RESEARCH REACTOR CENTER

Reference: Docket 50-186
University of Missouri-Columbia Research Reactor
Amended Facility License R-103

SUBJECT: Written communication as specified by 10 CFR 50.4(b)(1) regarding the response to the
“University of Missouri at Columbia – Request for Additional Information Re: License
Renewal, National Historic Preservation Act (TAC No. MD3034),” dated April 30, 2010

ATTACHMENT 1

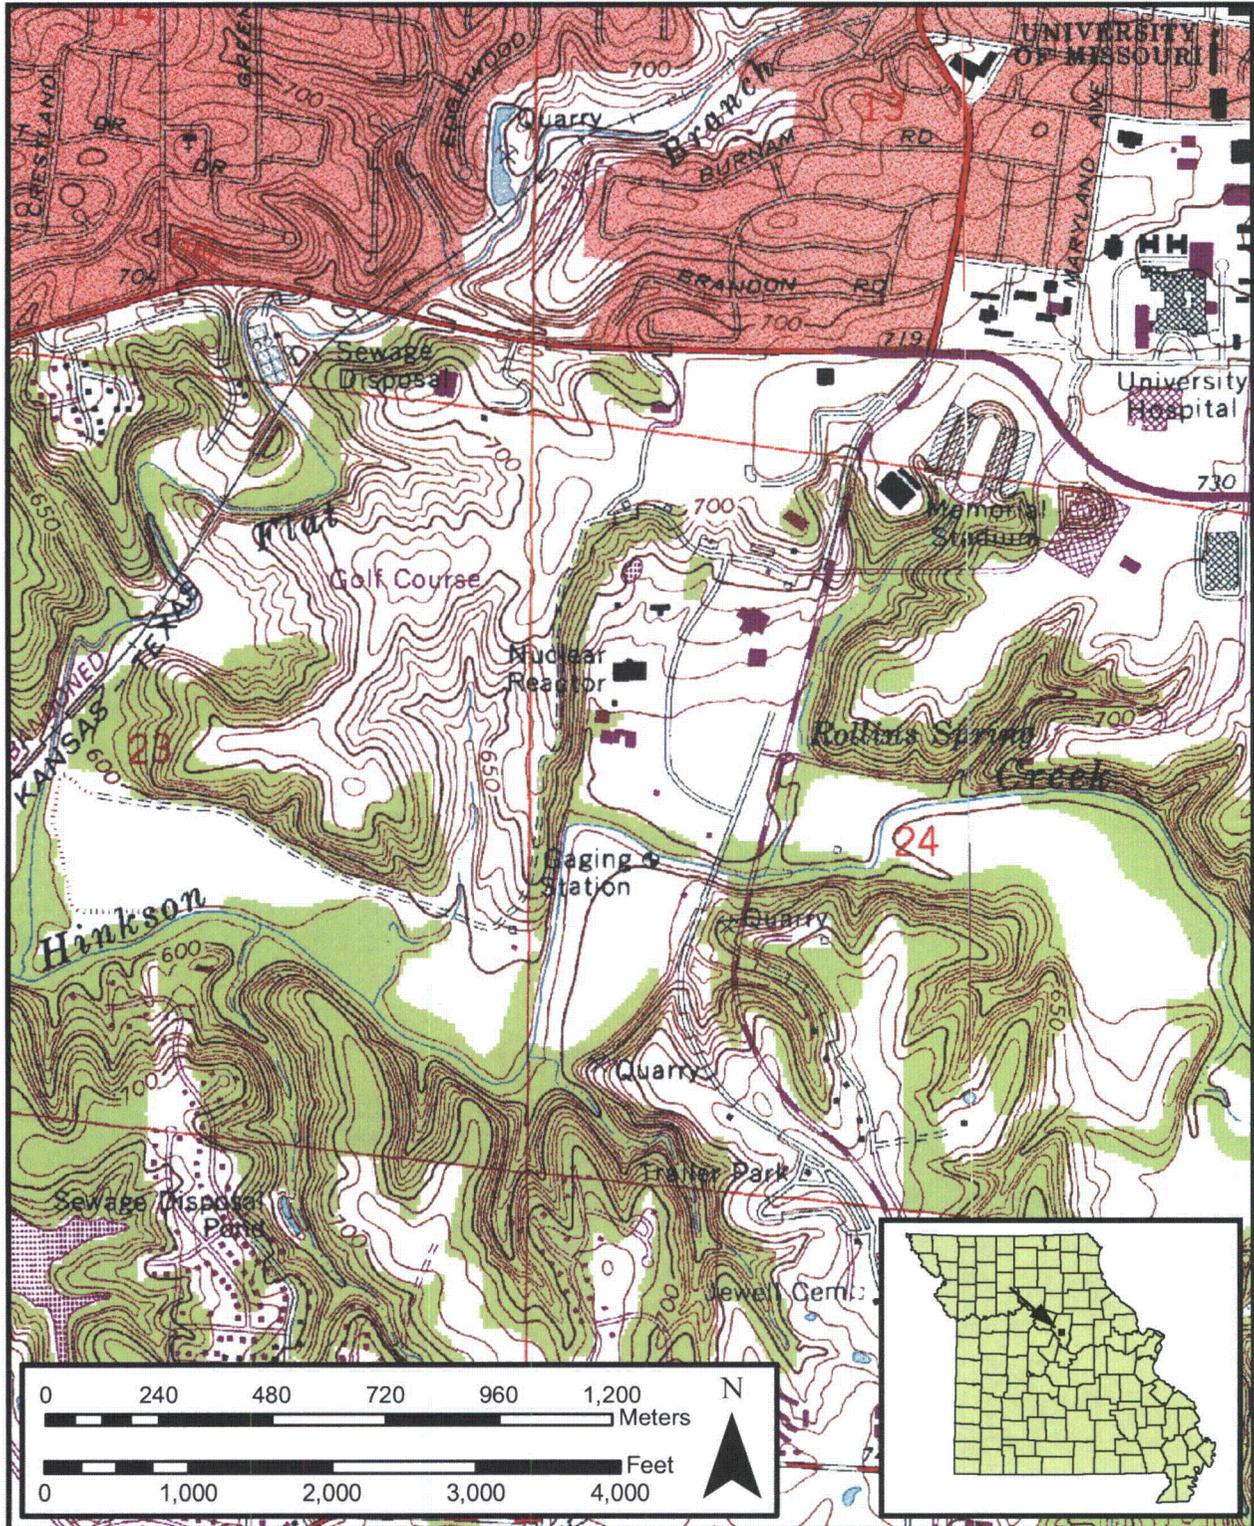
1. *Please provide the name of the United States Geological Survey (USGS) topological map quadrangle in which MURR is located. Also, for the map you are referencing, please state the year, township, range and section. Please attach a copy of the relevant portion (8½ x 11) of the current USGS 7.5 min. topographic map and, if necessary, a large scale project map. Please do not send an individual map with each structure or site. While the original map is preferable, a good copy is acceptable. USGS 7.5 min. topographic maps may be ordered from the Geological Survey and Resource Assessment Division, Department of Natural Resources, 111 Fairground, Rolla, MO 65402, Telephone: (573) 368-2125, or printed from the website <http://www.topozone.com/>.*

The MURR facility is located in the Columbia quadrangle, Missouri - Boone County, Township 48N, Range 13W and Section 24. The most current USGS 7.5 min. topographic map that is being referenced was printed in 1967 and photorevised in 1981. Attached are the relevant portion (8½" x 11") and large scale topographic maps of where the MURR site is located (Attachments 1 and 2).

ATTACHMENT 3

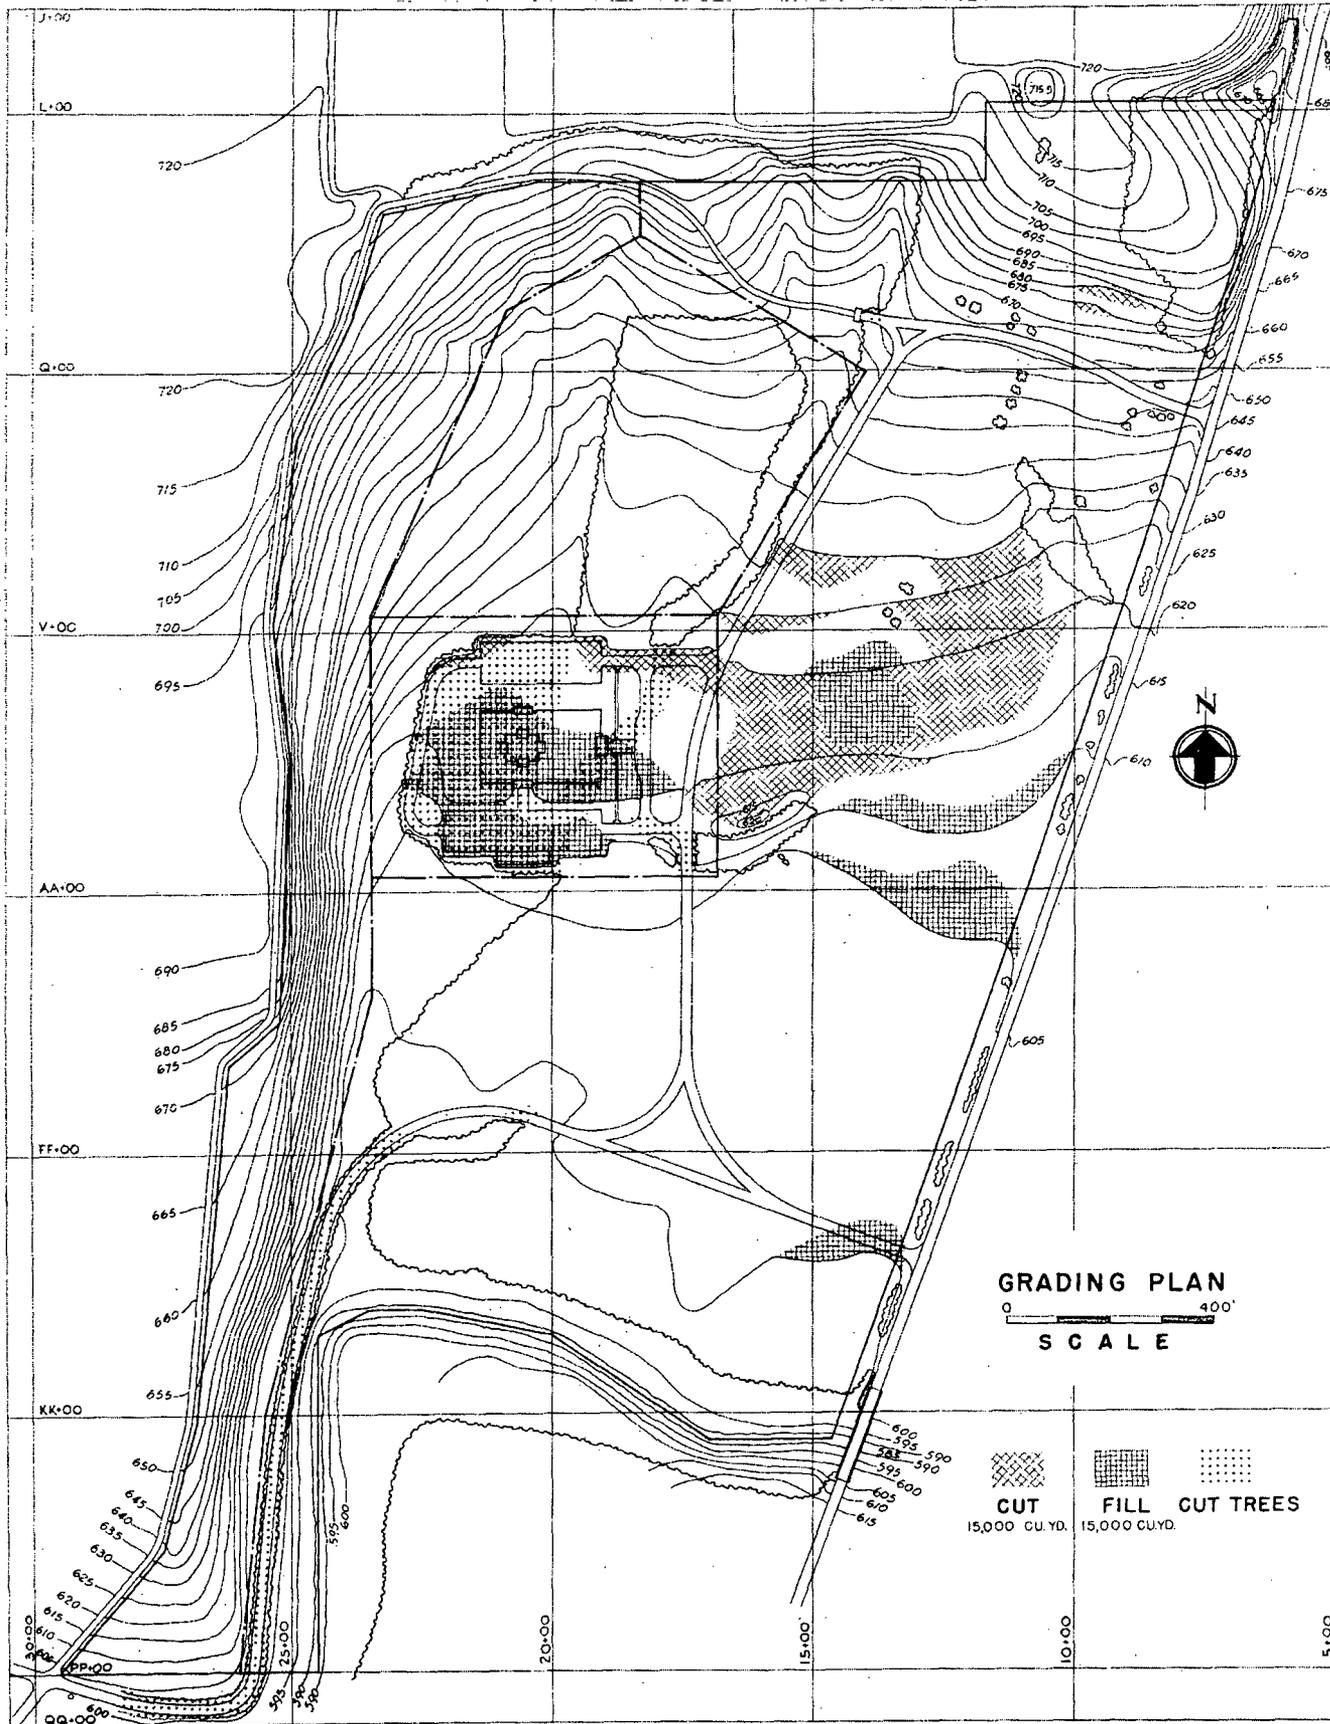
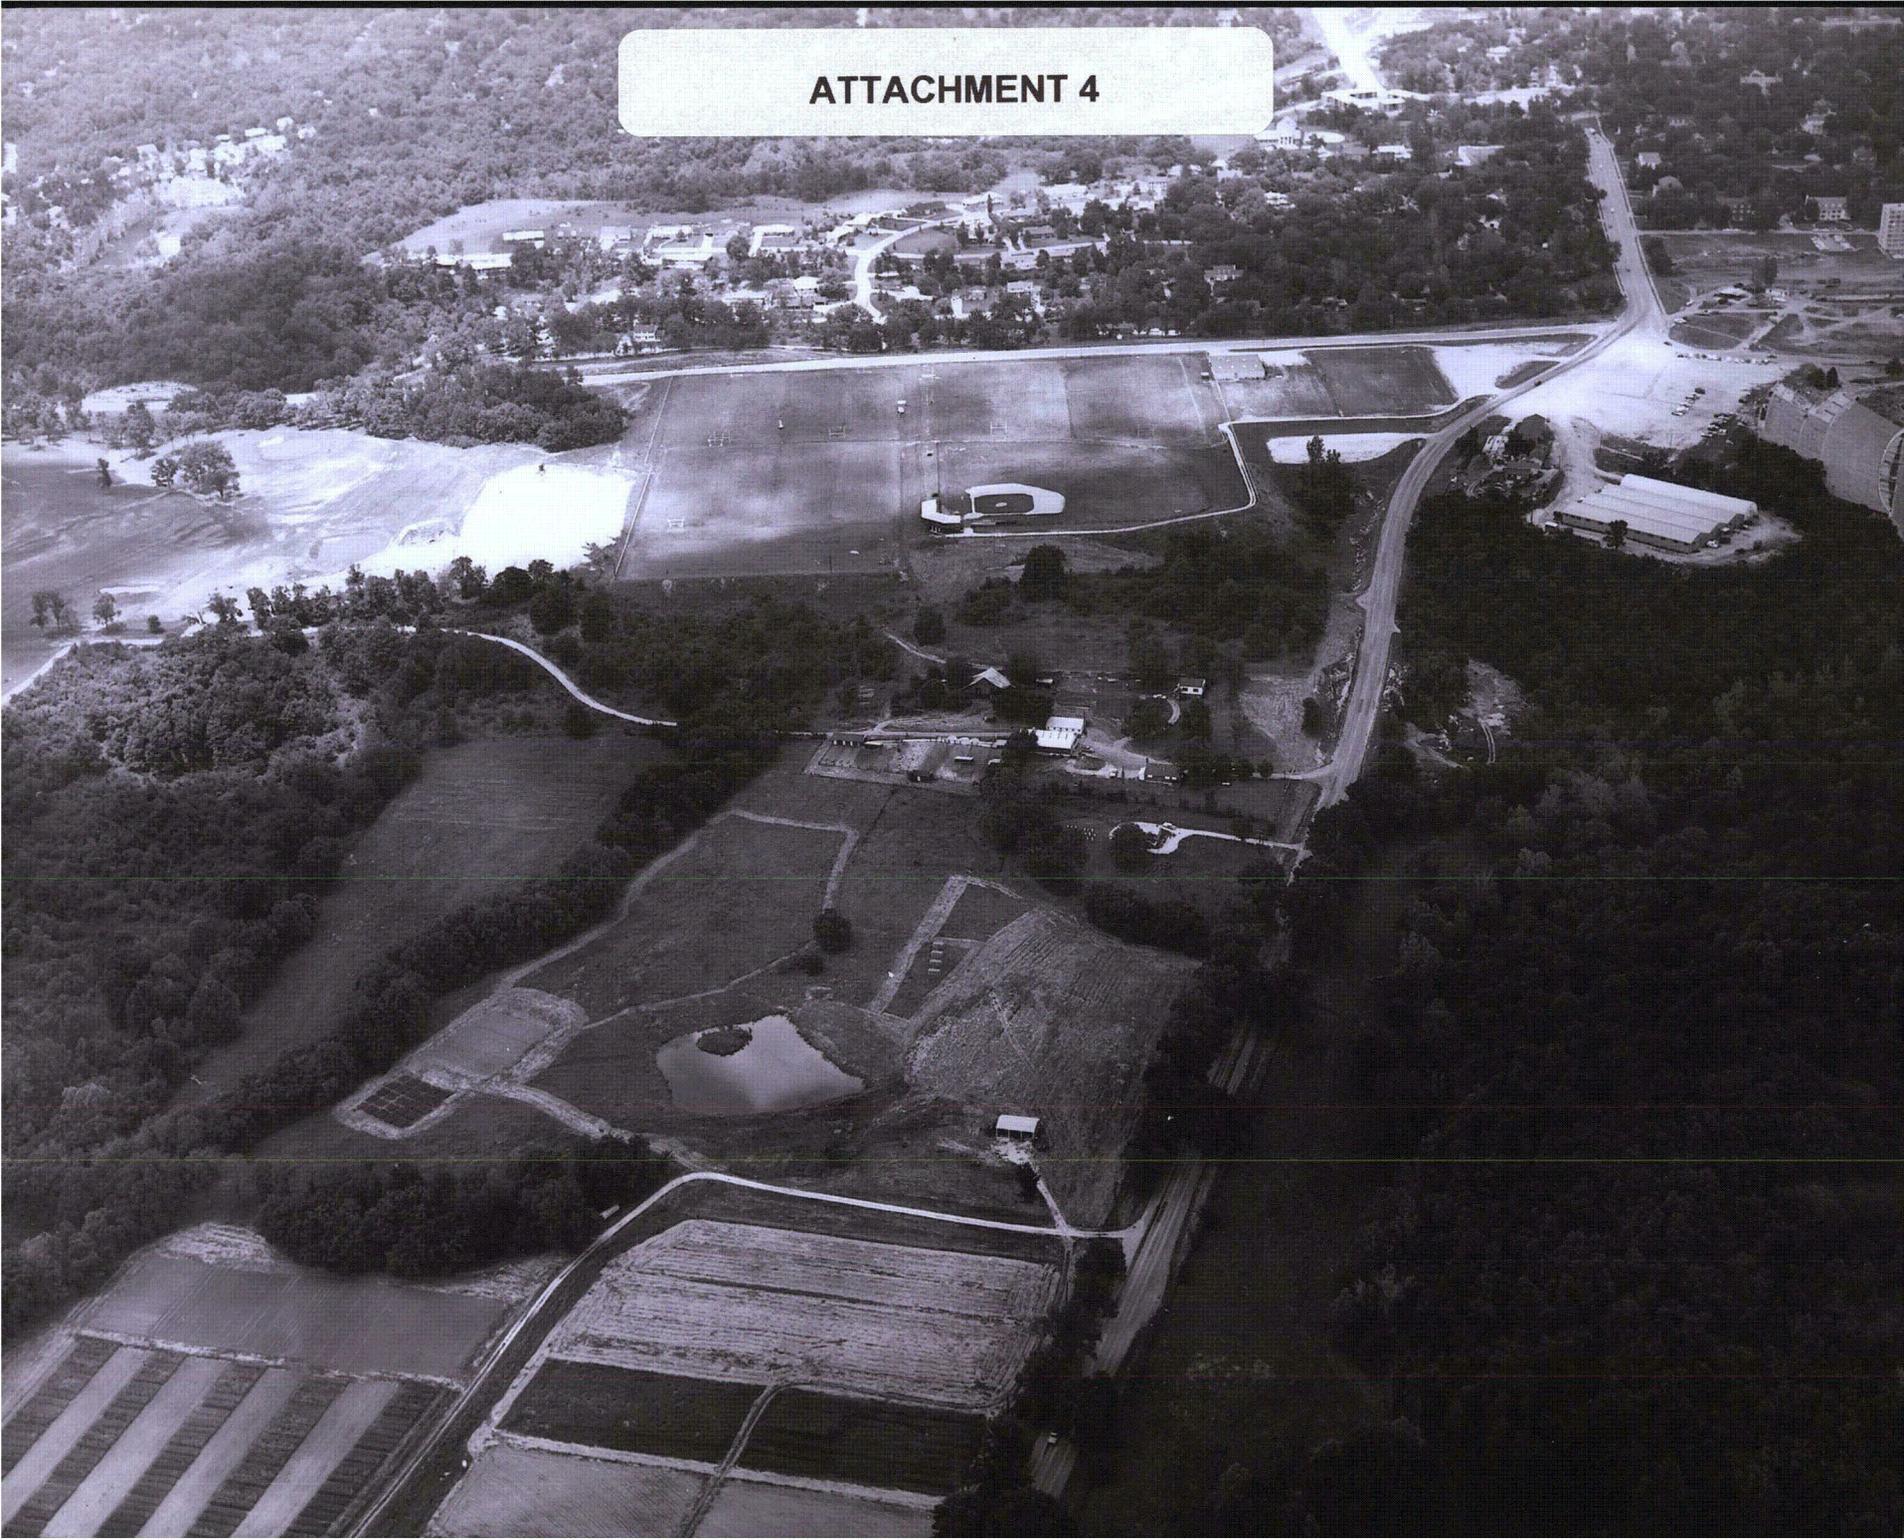
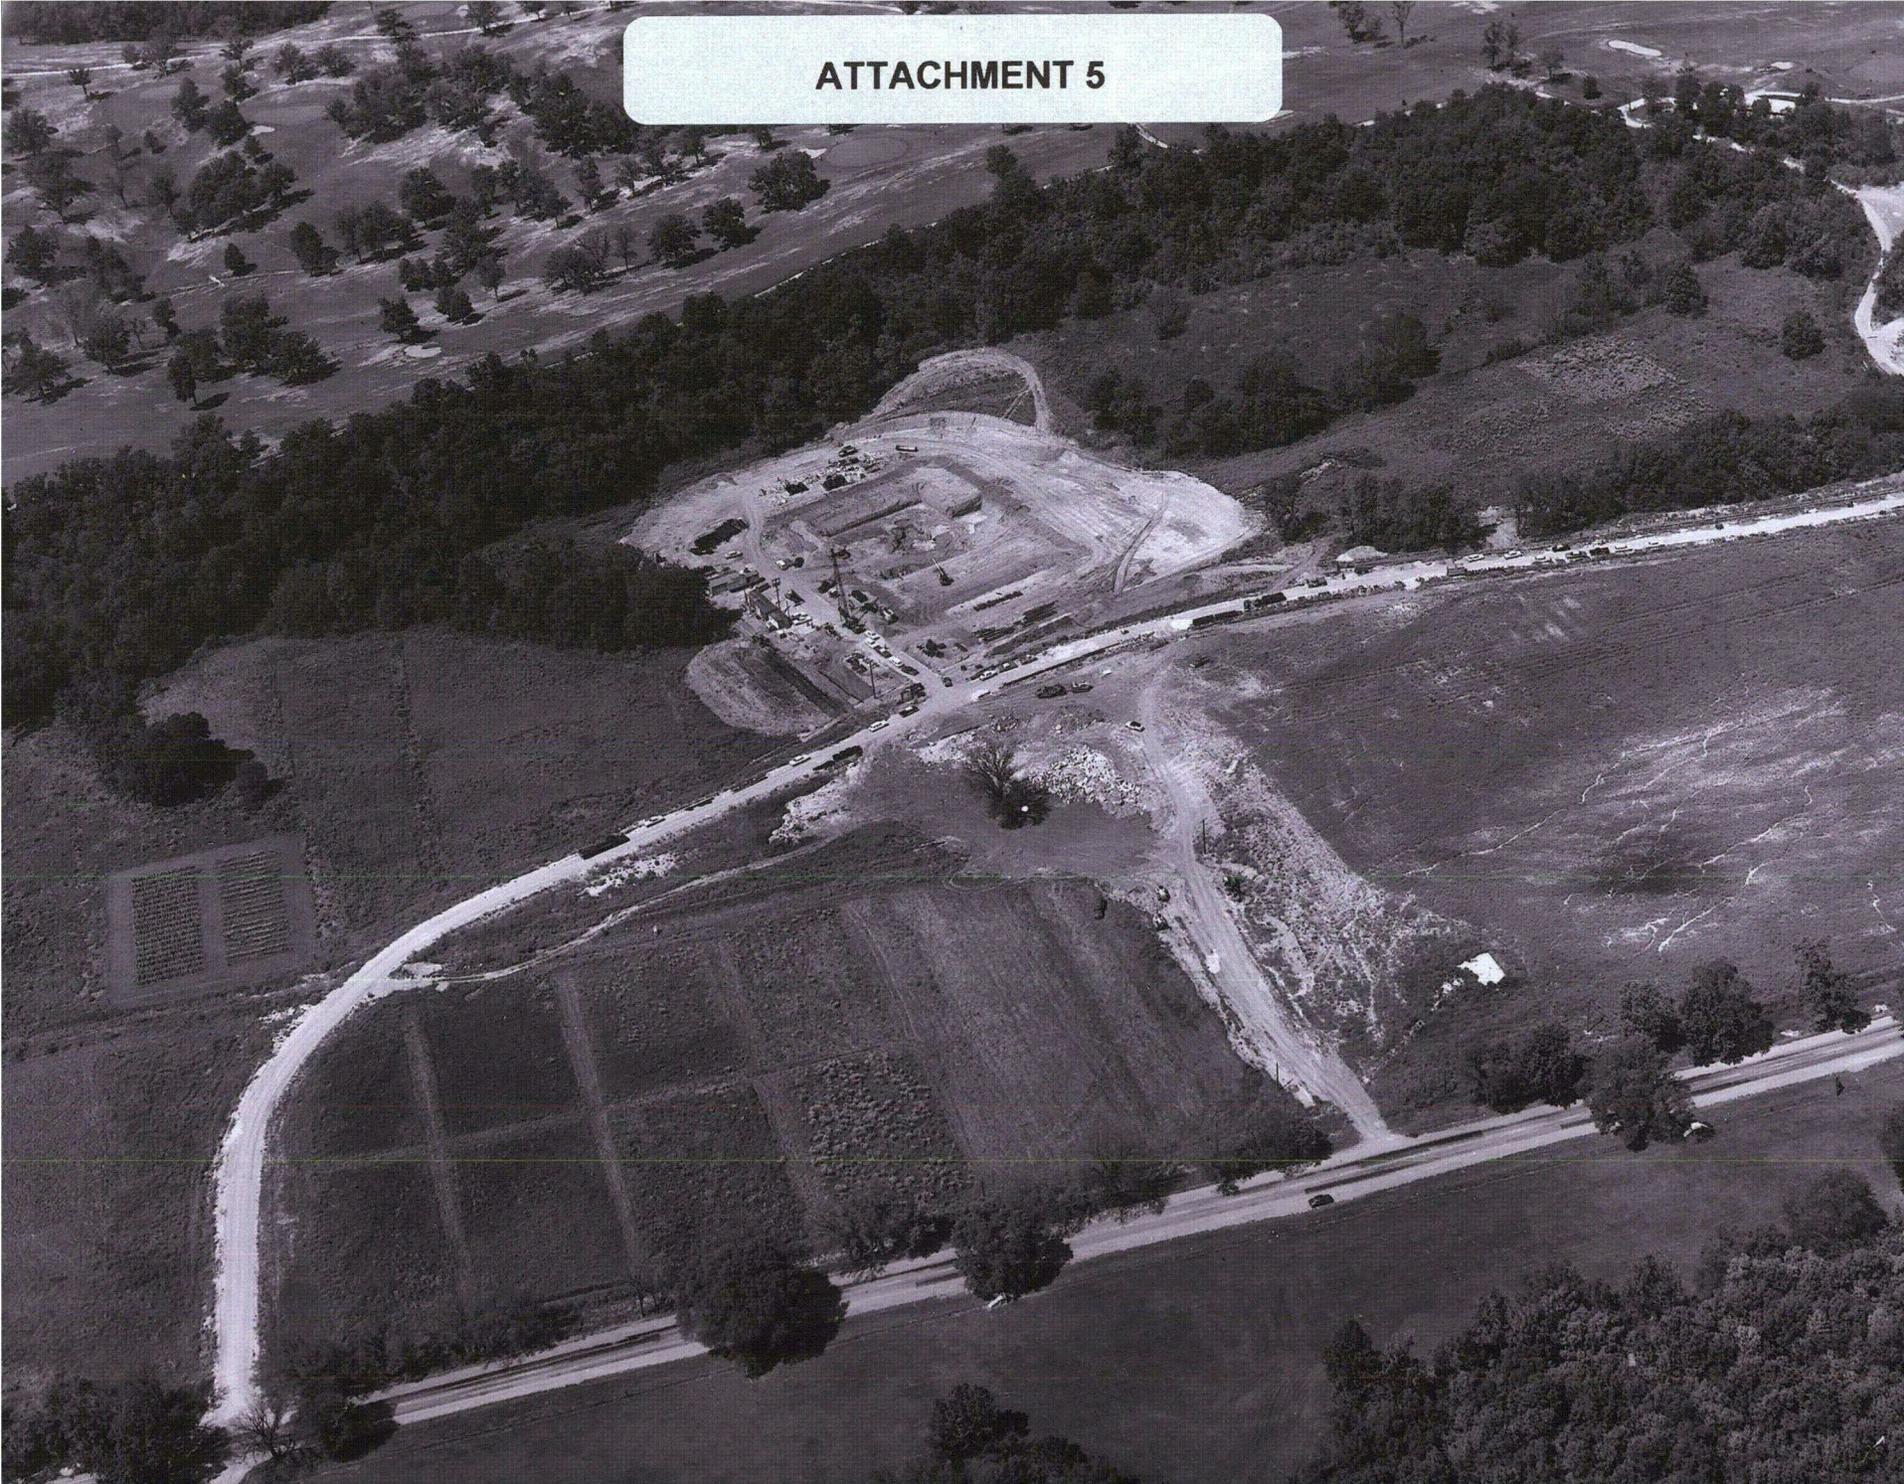
2. *For the MURR facility, please state if the ground involved was graded, built on, borrowed, or otherwise disturbed. If so, please describe in detail and provide photographs, if applicable. If fill material was used, indicate "borrow areas" on the topographic map from which fill material was taken.*

The building area of the MURR site at the time construction commenced had a gradual rise from south to north. In addition to the removal of existing trees on the site, approximately 15,000 cubic yards of fill was deposited on the south and central portions of the site. Fill material was removed from the east side of Research Park Drive (formerly known as "Reactor Park Road"). The attached topographic map (Attachment 3) indicates relevant fill and cut areas. Also attached are photos of the site prior to grading (Attachment 4) and after grading (Attachment 5).
